PSEG Public Service
Electric and Gas
Company

HOPE CREEK GENERATING STATION
DOCKET NO. 50-354
REVISED FSAR QUESTION RESPONSES

Attachment I contains the revised responses to FSAR Question 410.69 and 430.88. In addition, attached to 430.88 is one copy of "Summary of Reduced Standby Diesel Generator Loading to accommodate a standing hurricane after a Loss of Offsite Power." These question responses were revised per discussions held with the auxiliary system and power system branches respectively.

FIGURE 430-88-1

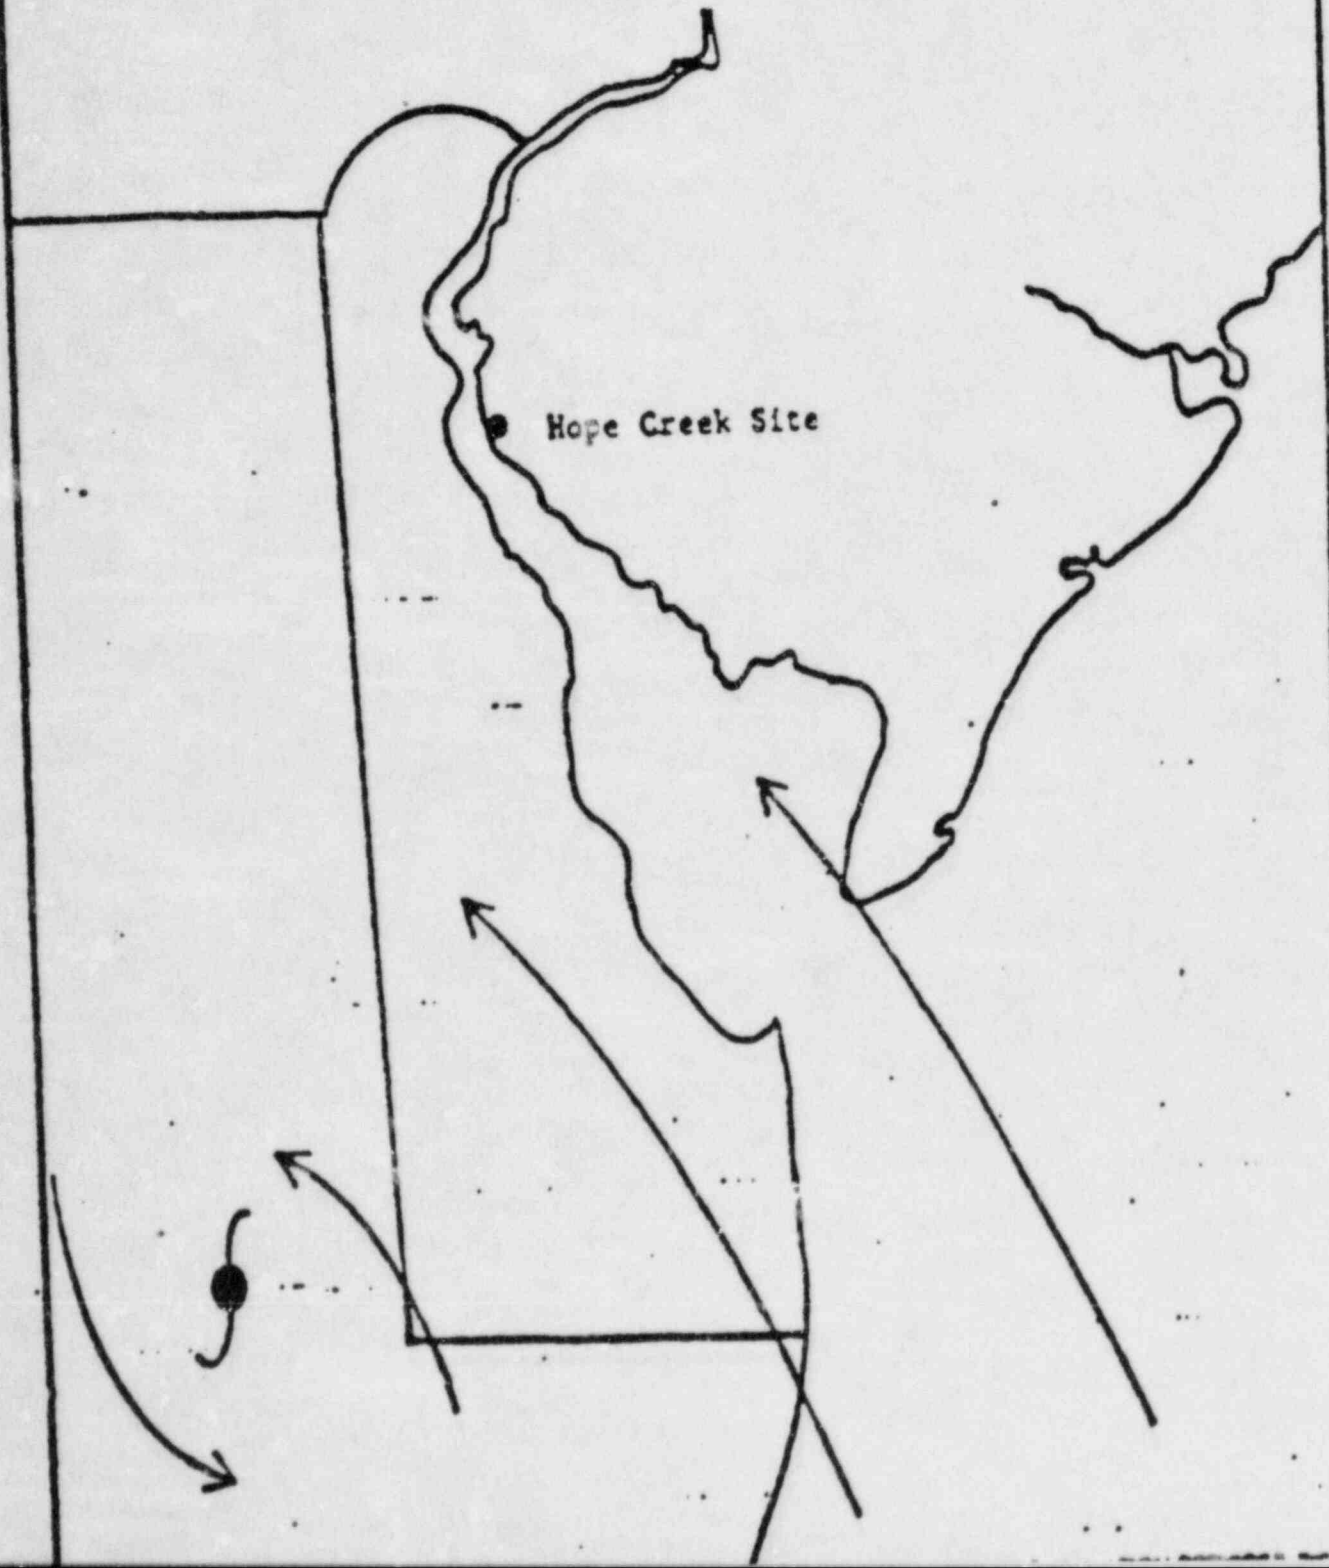
Provide additional justification to support your statement in Section 9.5.4.3 that sufficient additional fuel can be delivered to the plant site by truck, or barge. In your discussion include sources where diesel quality fuel oil is available and distances travelled from the source to the plant. Also discuss how fuel oil will be delivered onsite under extremely unfavorable environmental conditions. (SRP 9.5.4, Part I)

A. Hurricane stationary in the least favorable position (see Figure 430.88-1)

A hurricane in this position is largely cut off from oceanic moisture and it is subject to frictional erosion of its wind speeds. It will decay into a wet, showery situation with modest wind speeds within 12-24 hours.

While extremely adverse wind, weather and tidal conditions at the Hope Creek Site could interfere with diesel oil delivery for approximately 24-36 hours, it would be a very improbable situation that would preclude delivery by ~~all of the possible avenues~~ ^{truck or barge} ~~(trailer, barge or helicopter)~~ for as long as 60 hours.

There are three key factors which support this conclusion. First, while any storm can remain stationary for an extended period, one in an adverse position (onshore) will lose its energy source and be eroded by surface friction. Secondly, any storm remaining offshore where it can retain all or some of its energy source will be in a position either to cause unusually low tides following the initial surge, or at least to provide shelter from the maximum winds because of the long fetch over the lower Jersey peninsula. Thirdly, the storm surge capable of seriously flooding the area is an enormous wave and it will not maintain site area flooding condition for prolonged periods (24-36 hours) even if the driving force continues.

FIGURE 430.88-2
HOPE CREEK
GENERATING STATION
Offshore Hurricane - Wind Flows

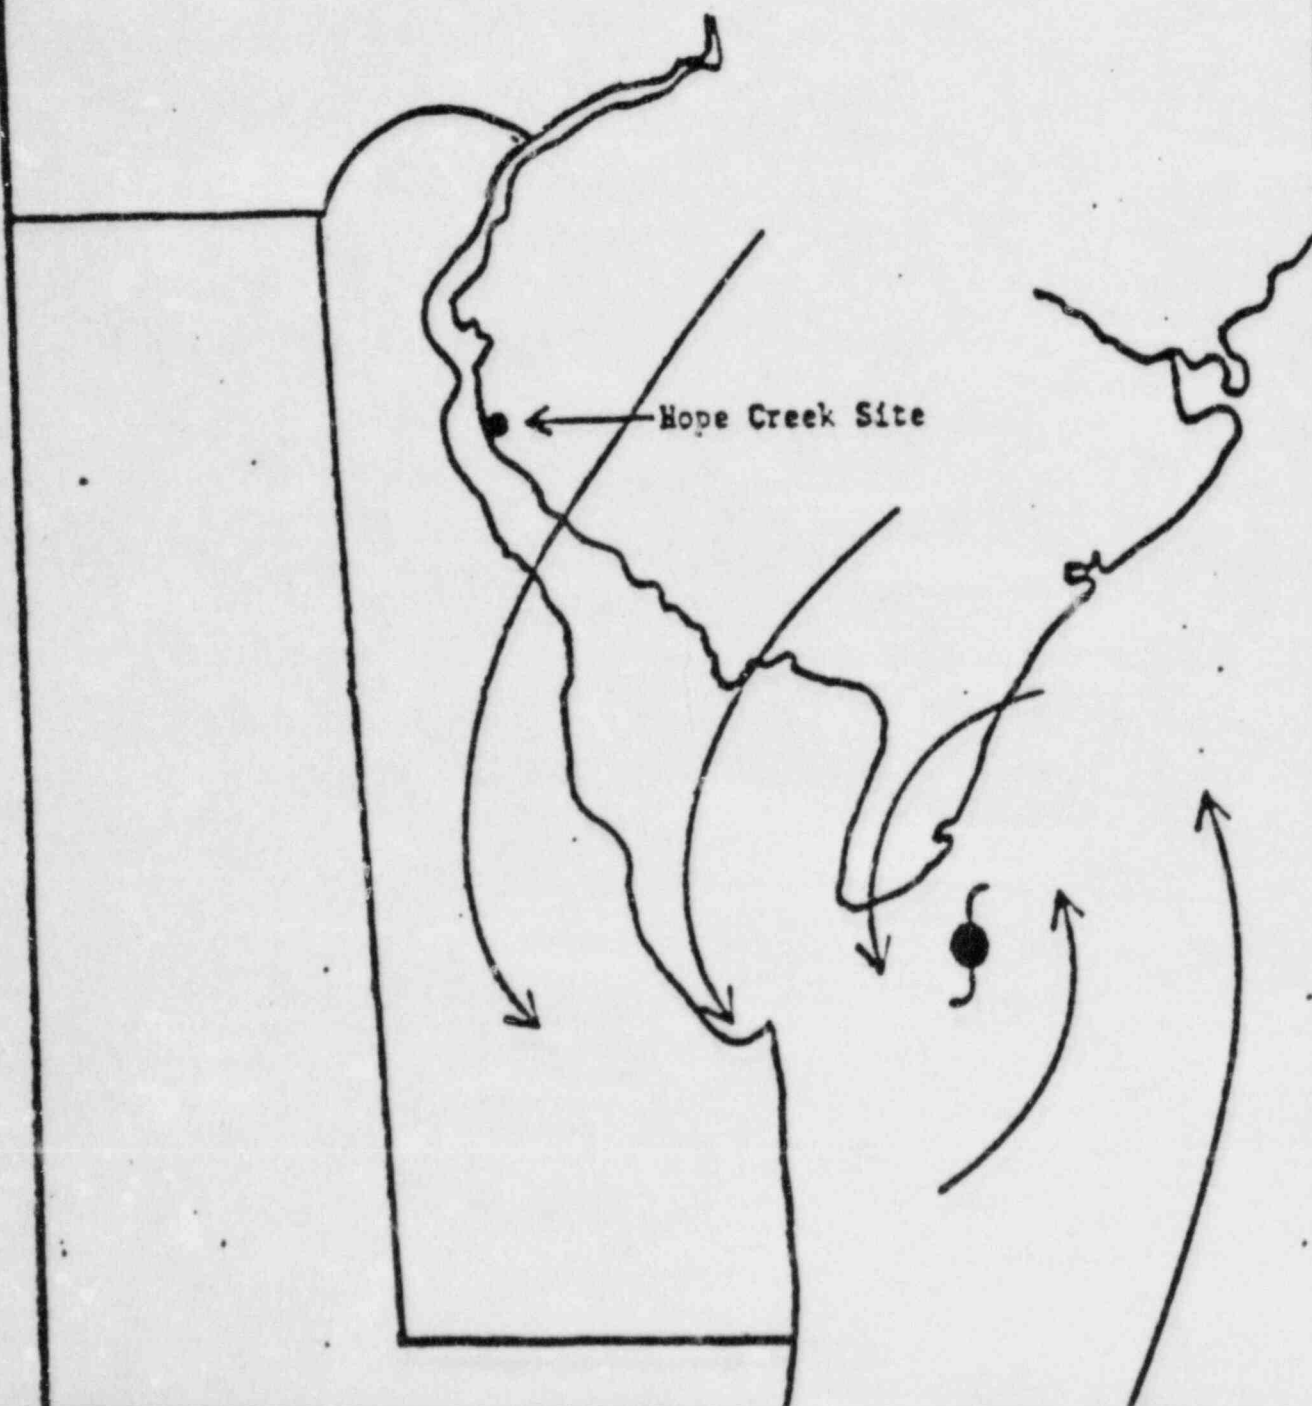
B. Hurricane stationary off the coast (see Figure 430.88-2)

A hurricane anywhere off the coast would continue to receive a substantial portion of its energy and it would not be affected by friction of the land surface. However, its location would preclude the fetch necessary to drive water directly into the bay, and the flow over the peninsula would moderate the winds at the site. The initial surge should drop within 12 hours and would probably be followed by an abnormally low tide. The clouds and showers associated with the storm might last 24-36 hours.
